Agreed changes:  
Deletions in ~~red strikethrough~~  
Additions in blueDHHS disagree in yellow  
Council disagree in green--/2017  
C157**SCHEDULE 3 TO CLAUSE 43.04 DEVELOPMENT PLAN OVERLAY**Shown on the planning scheme map as **DPO3**.**PUBLIC HOUSING RENEWAL - NEW STREET, BRIGHTON**

**Development Concept Plan**

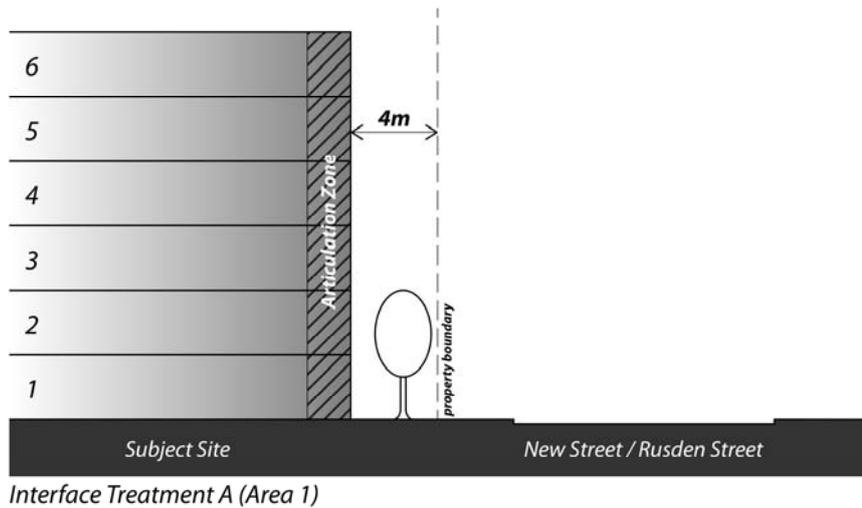
**Council:** The word generally here would allow two layers of general accordance which would result in a lack of certainty/unacceptable ambiguity

**DHHS:** It is unreasonable to expect the development to be exactly as shown on the Concept Plan.

The DPO as written provides for alternatives to be pursued through the Development Plan such as the location of small scale retail, the pedestrian path through the site and the location of open space. Providing the words "generally" allow the Responsible Authority to make a performance based decision to get the best outcome on the site.

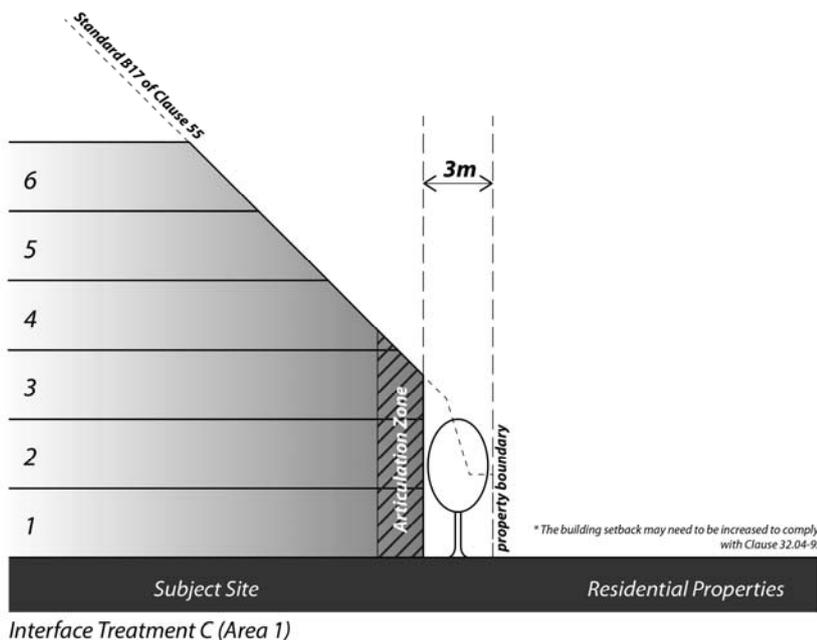
**DHHS and COUNCIL:** Agree that the Development Plan is where trees to be retained are to be identified and that this will result in the setback required on Brickwood Street.

**Council:** Council expects that even if reduced, the DP will provide for building modulation to accommodate 7-8m of canopy from title boundary, as per the Apartment Design Guidelines.

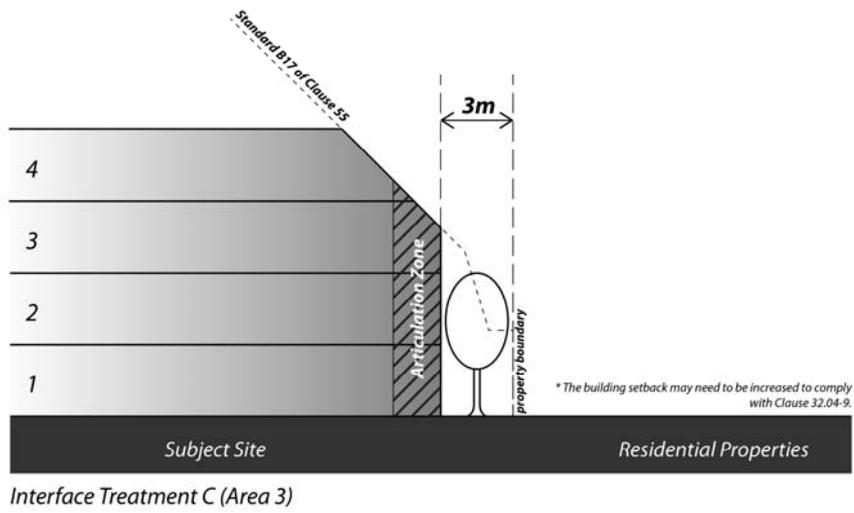
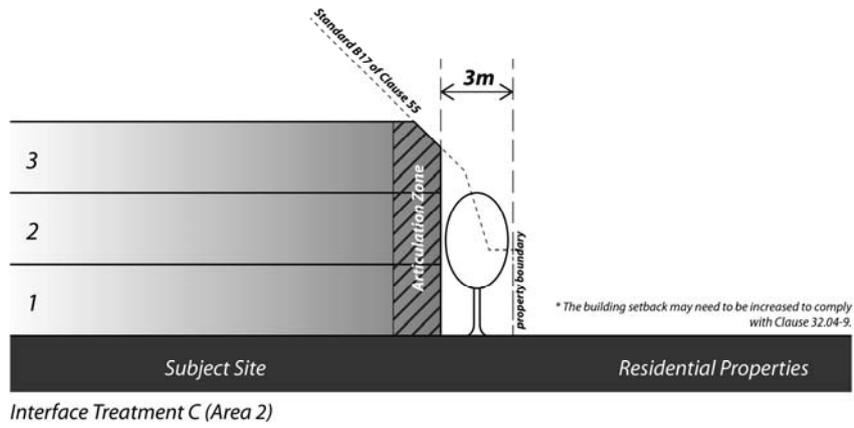
**Council:** Section between Rusden St and Salisbury Street is not characterised by trees – better to reference the potential ability to provide a pedestrian connection here and along Elster Creek, or provide a landscaped interface (canopy trees would not be replacing anything along this interface).

If a pedestrian link is retained, then this minimum setback should be increased as required to accommodate landscaping and canopy trees

**DHHS:** This requirement is to allow for both the protection of any existing trees or new trees.

The clause as written allows for the setback to be increased to allow for landscaping and canopy trees, there is no need for a change.

Interface Treatment D (Area 1)

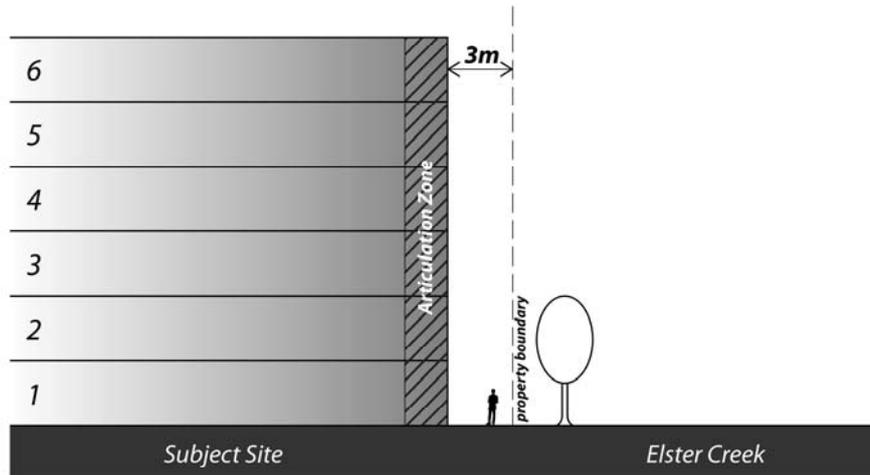
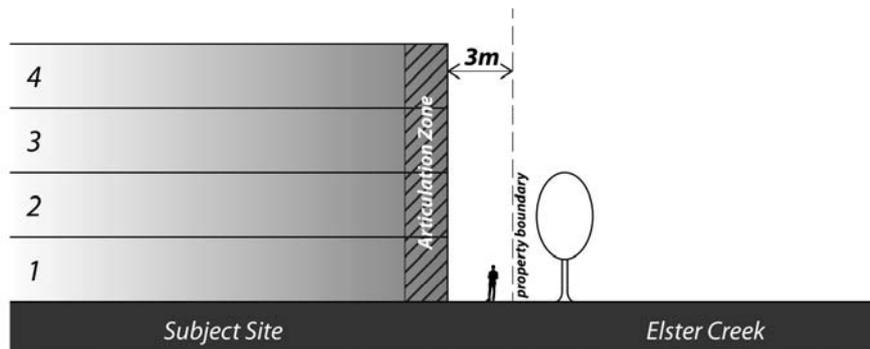
**Council:** The setback is specified as a minimum. Therefore, it should not be 'as shown.' Council wants to see building modulation to accommodate canopy trees, plus a minimum landscape strip between the articulation zone and the pathway. Hence 4m should be the absolute minimum.

**DHHS:** The sections are indicative to give illustration to the above text. The words "as shown" are appropriate.
